# Town of Hilton Head Island Regular Design Review Board Meeting

Tuesday, July 10, 2012

PROJECT NAME: Supervisor's House Renovation & Addition  
(The Coastal Discovery Museum at Honey Horn) – ALTERATION & ADDITION

PROJECT NAME: Coligny Beach Park – ALTERATION & ADDITION

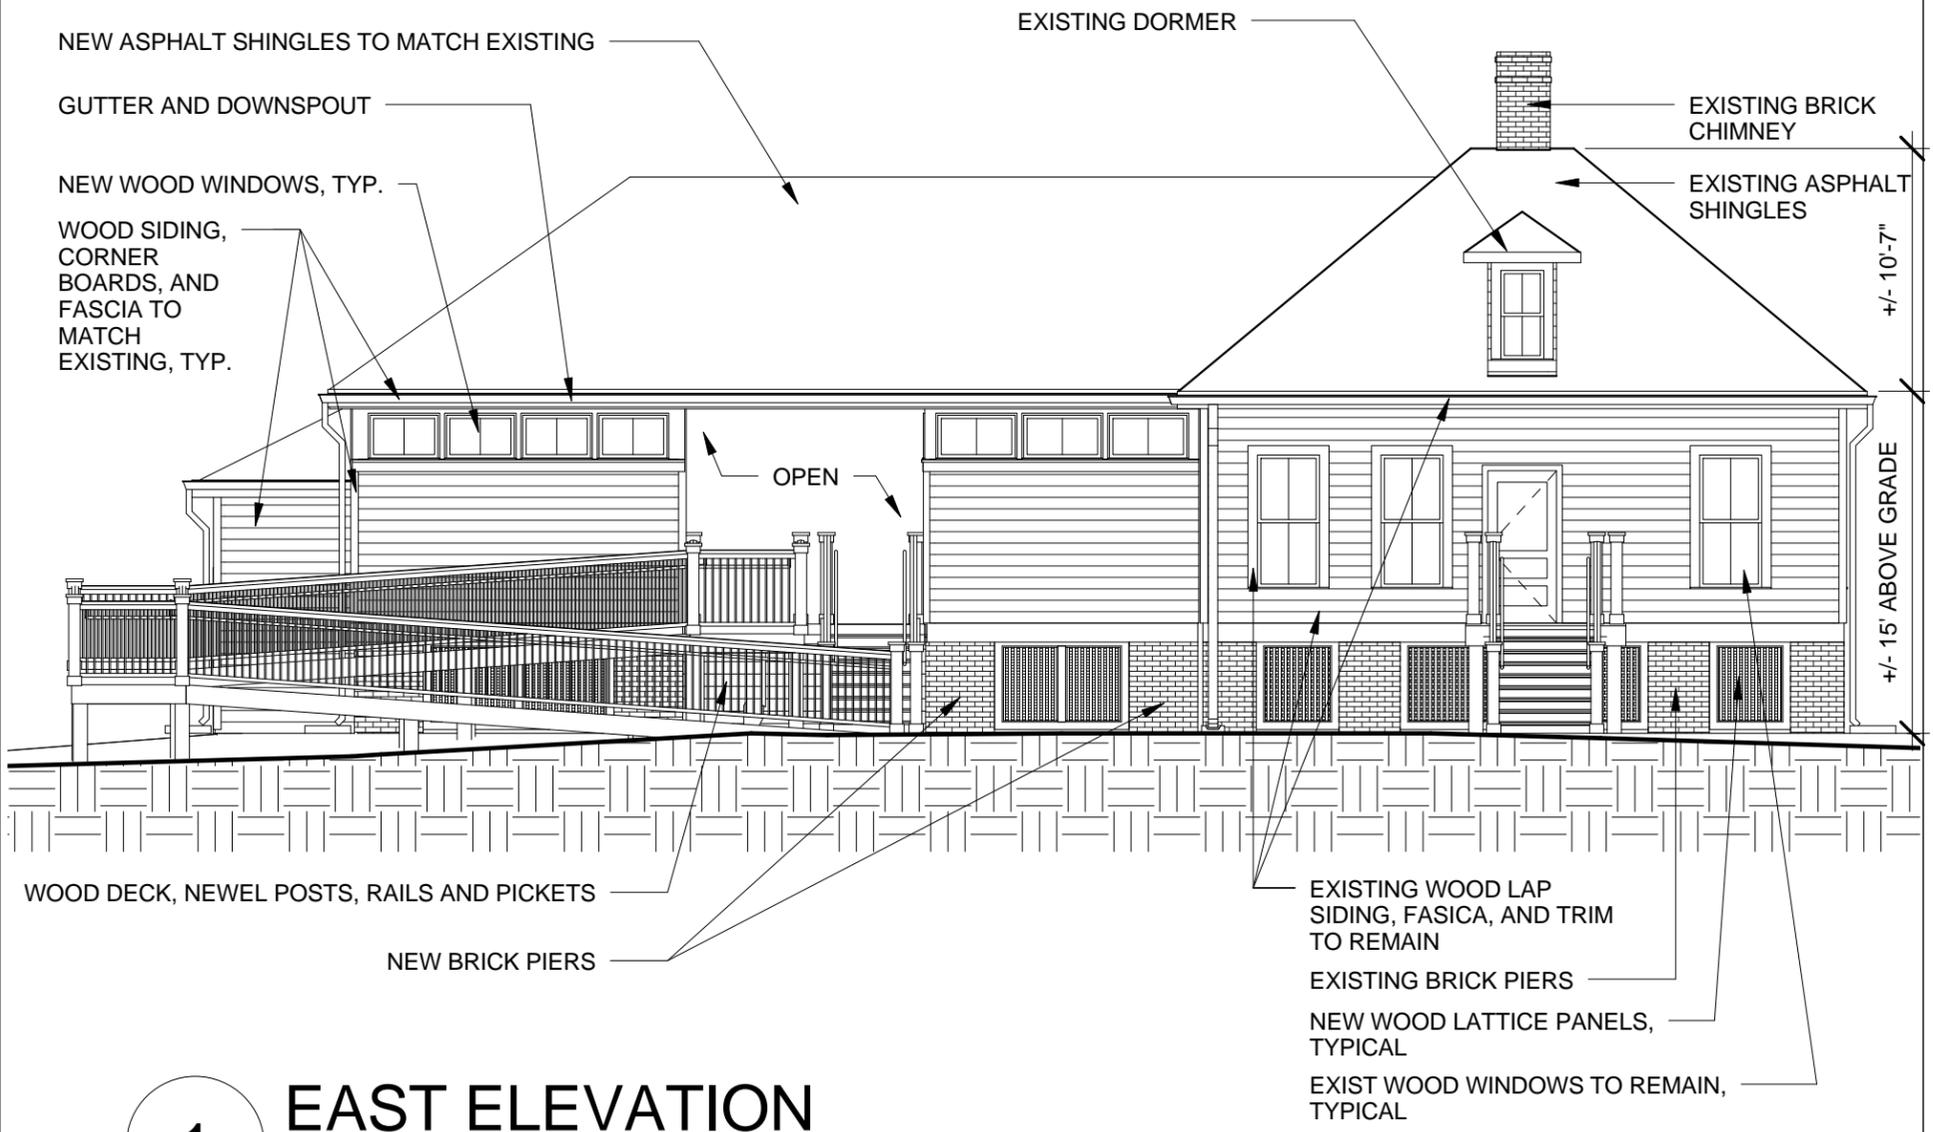
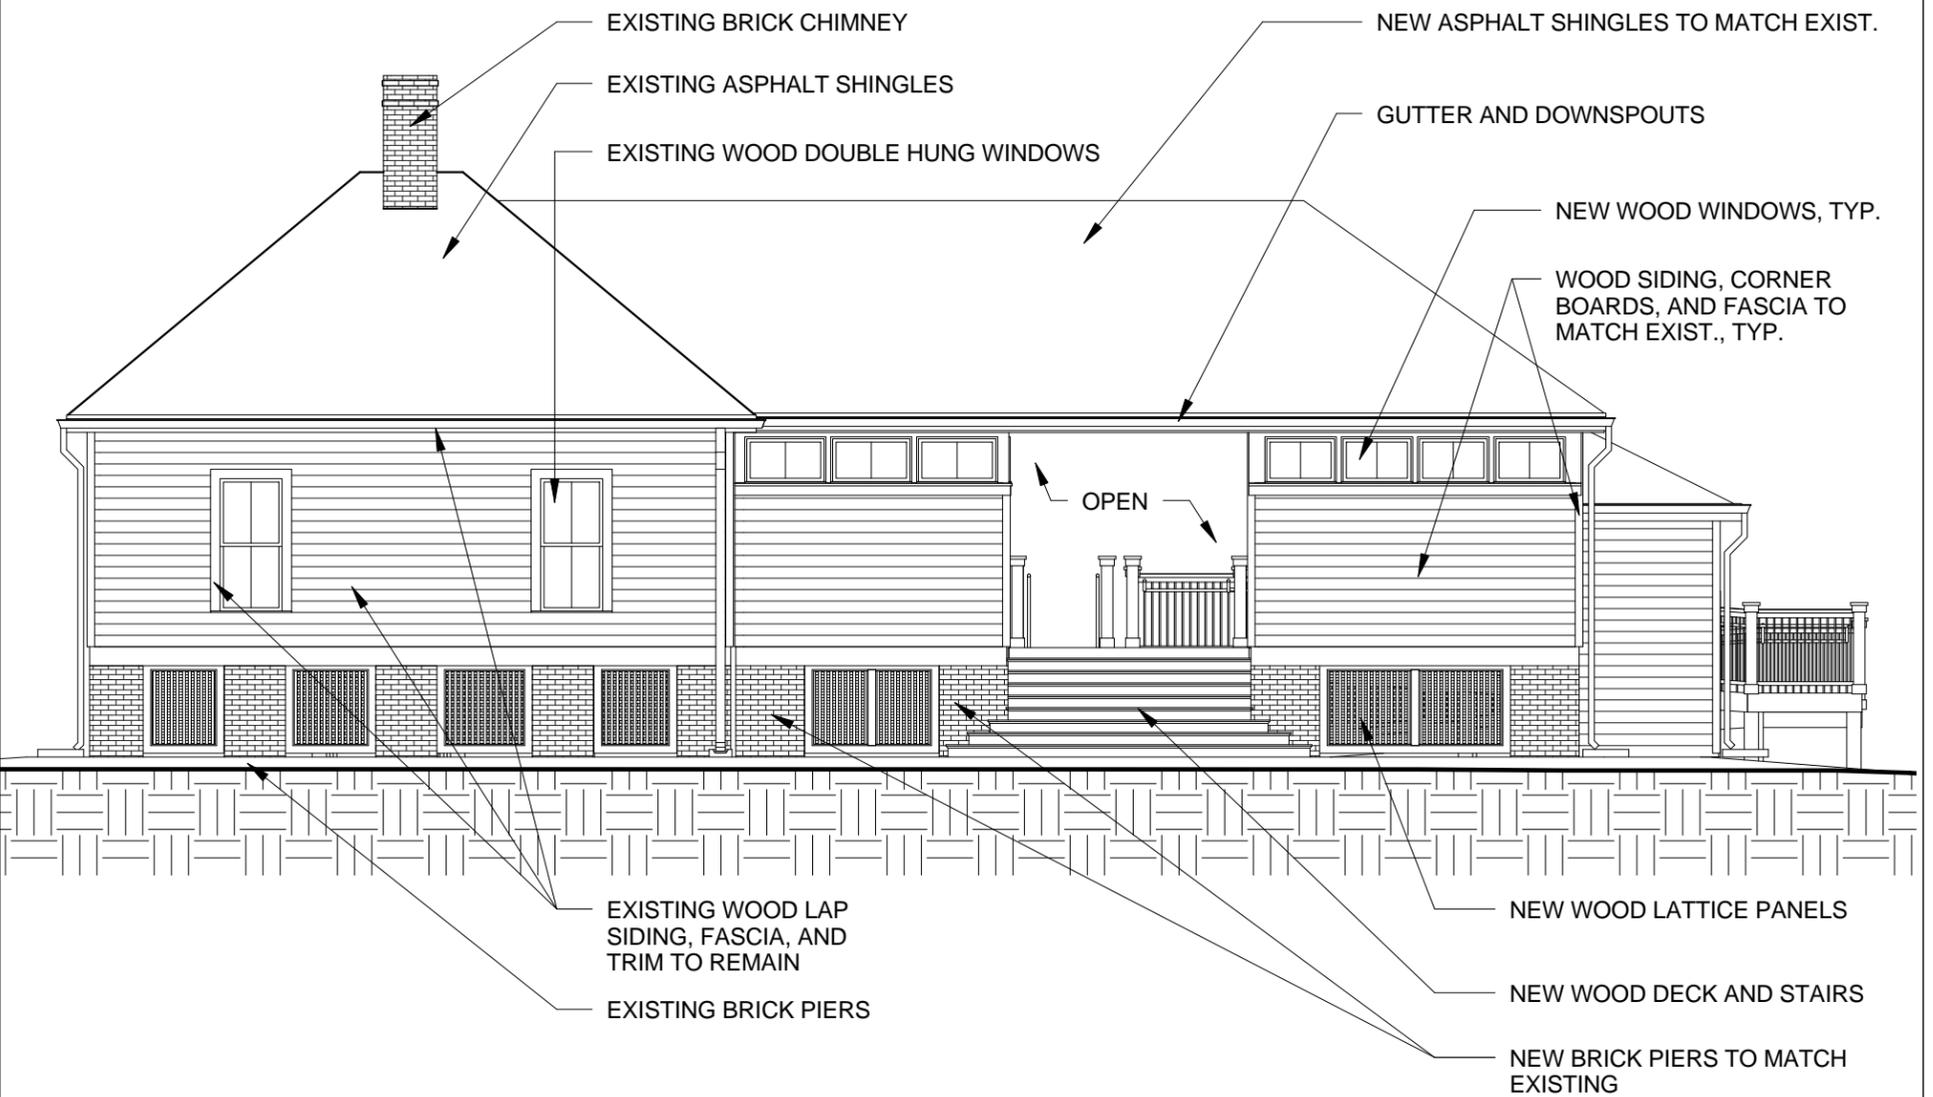
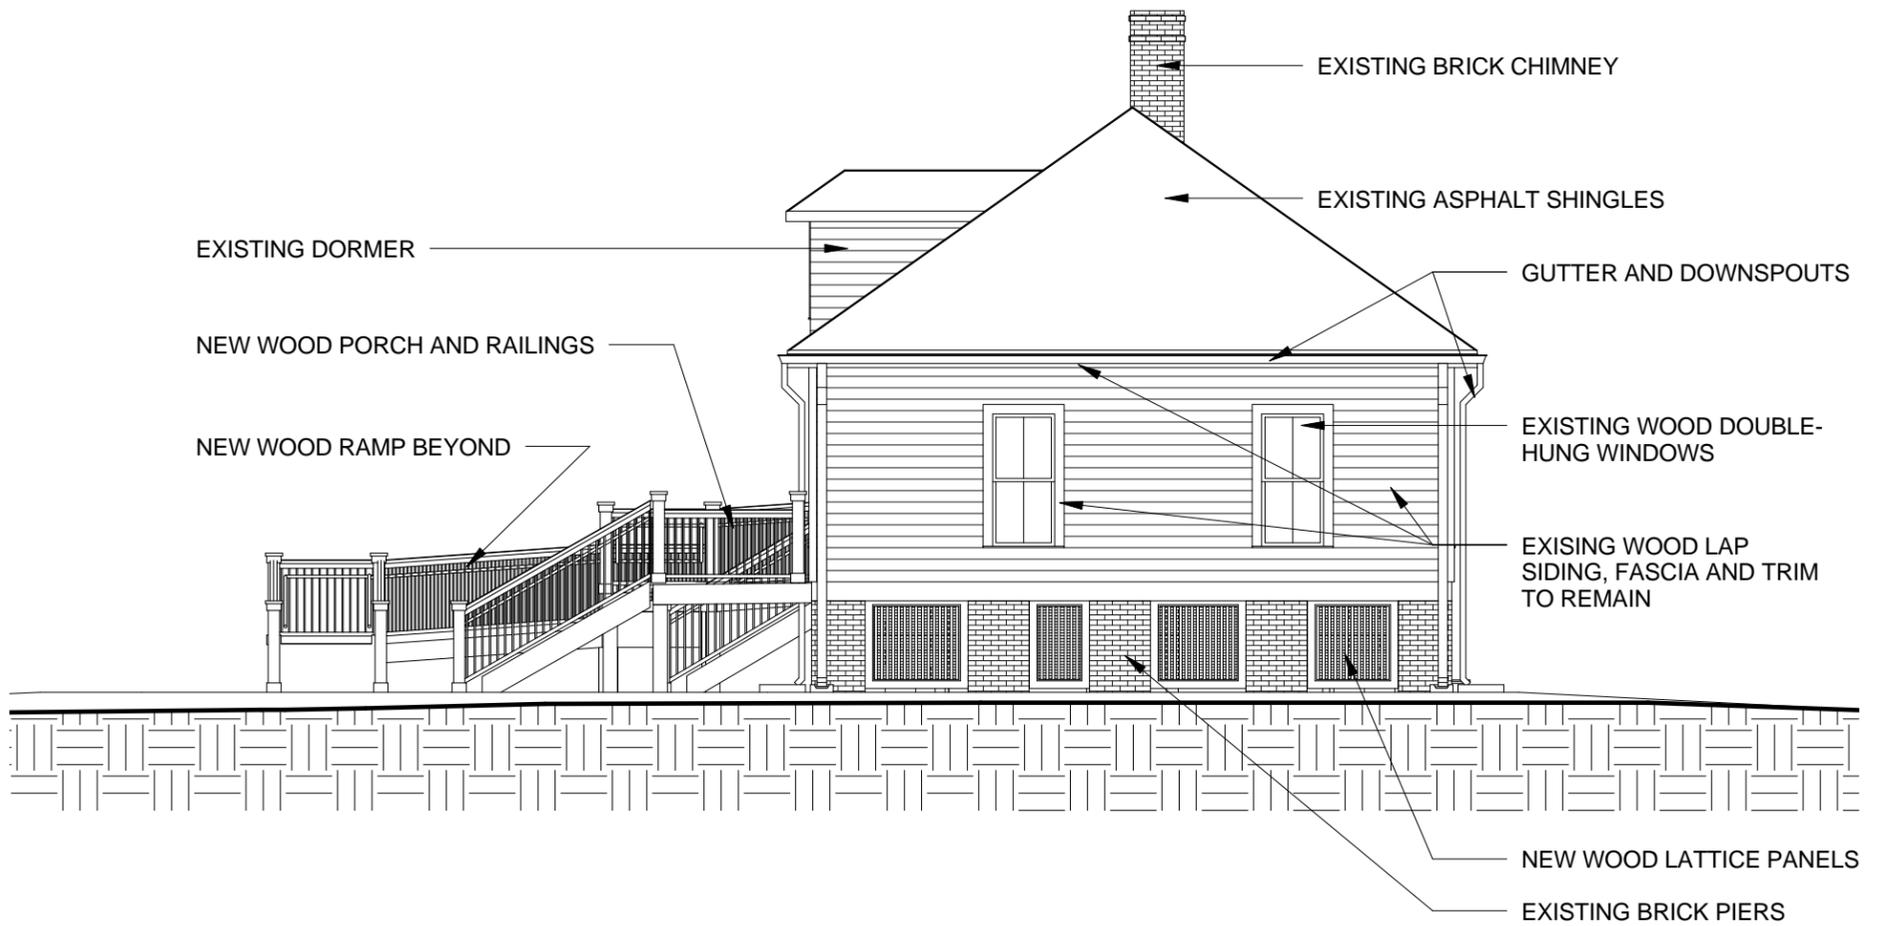
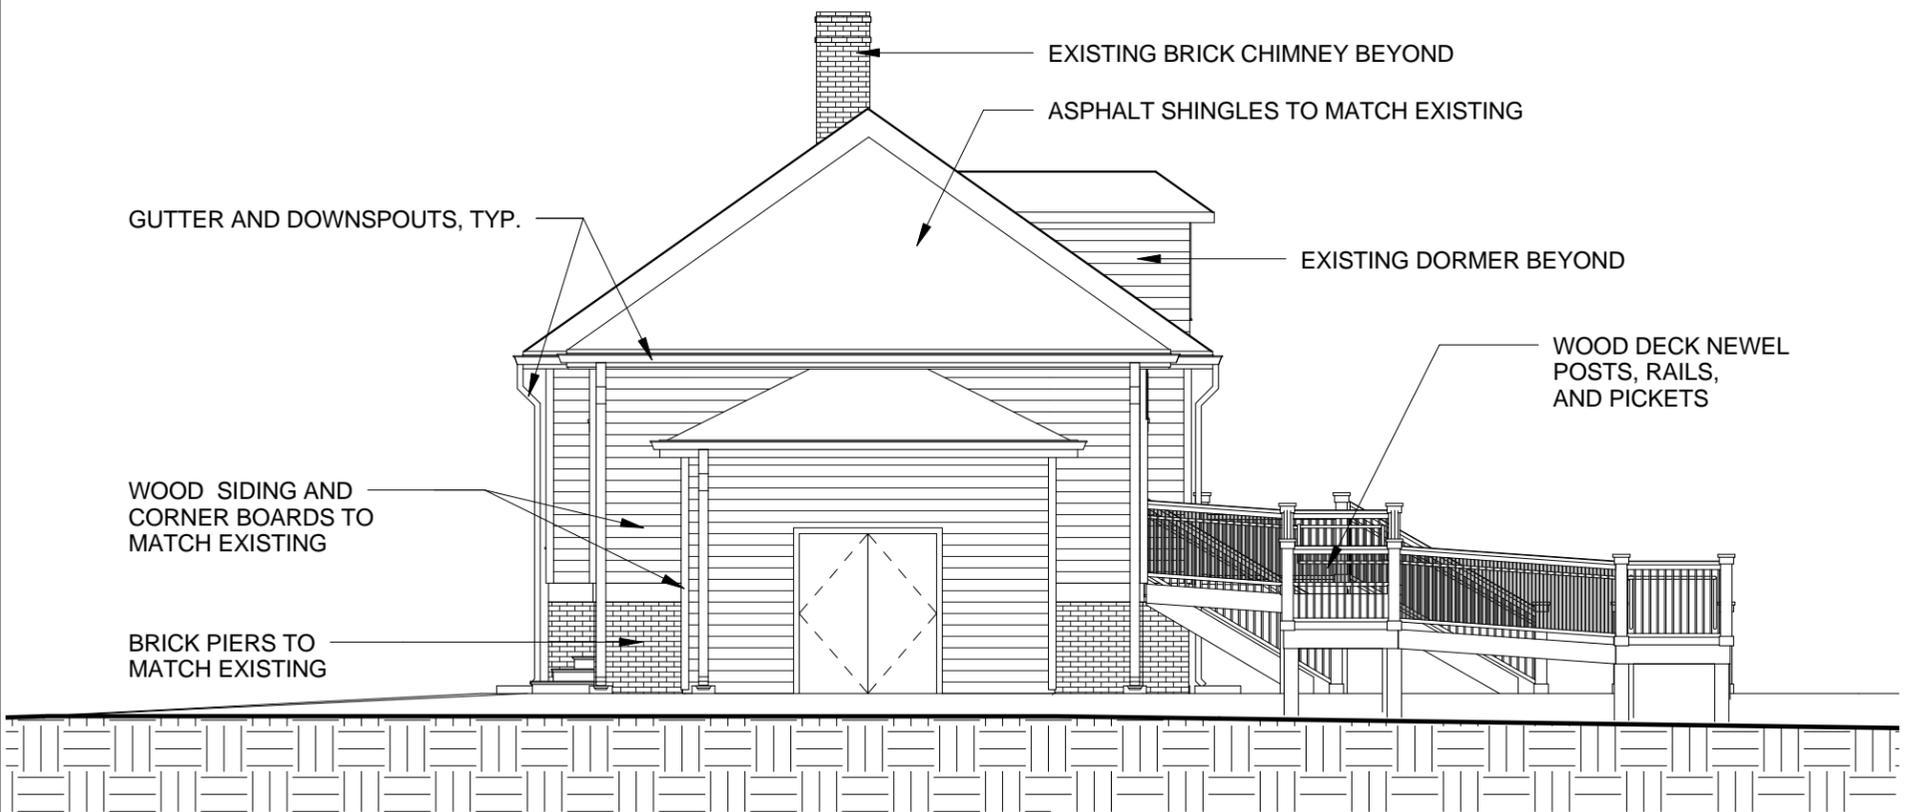
Design is appropriate for its use	<input checked="" type="checkbox"/>	<input type="checkbox"/>	<input type="checkbox"/>	
All facades are have equal design characteristics	<input checked="" type="checkbox"/>	<input type="checkbox"/>	<input type="checkbox"/>	
Avoids monotonous planes or unrelieved repetition	<input checked="" type="checkbox"/>	<input type="checkbox"/>	<input type="checkbox"/>	
Has a strong roof form with enough variety to provide visual interest	<input checked="" type="checkbox"/>	<input type="checkbox"/>	<input type="checkbox"/>	
Minimum roof pitch of 6/12	<input type="checkbox"/>	<input type="checkbox"/>	<input checked="" type="checkbox"/>	Roof pitch of addition complements existing roof pitch.
Overhangs are sufficient for the façade height.	<input checked="" type="checkbox"/>	<input type="checkbox"/>	<input type="checkbox"/>	Overhangs of addition are similar to existing

overhangs.
Forms an details are sufficient to reduce the mass of the structure	<input checked="" type="checkbox"/>	<input type="checkbox"/>	<input type="checkbox"/>	
Human scale is achieved by the use of proper proportions and architectural elements	<input checked="" type="checkbox"/>	<input type="checkbox"/>	<input type="checkbox"/>	
Utilizes a variety of materials, textures and colors	<input checked="" type="checkbox"/>	<input type="checkbox"/>	<input type="checkbox"/>	
Incorporates wood or wood simulating materials	<input checked="" type="checkbox"/>	<input type="checkbox"/>	<input type="checkbox"/>	
Windows are in proportion to the facade	<input checked="" type="checkbox"/>	<input type="checkbox"/>	<input type="checkbox"/>	
Details are clean, simple and appropriate while avoiding excessive ornamentation	<input checked="" type="checkbox"/>	<input type="checkbox"/>	<input type="checkbox"/>
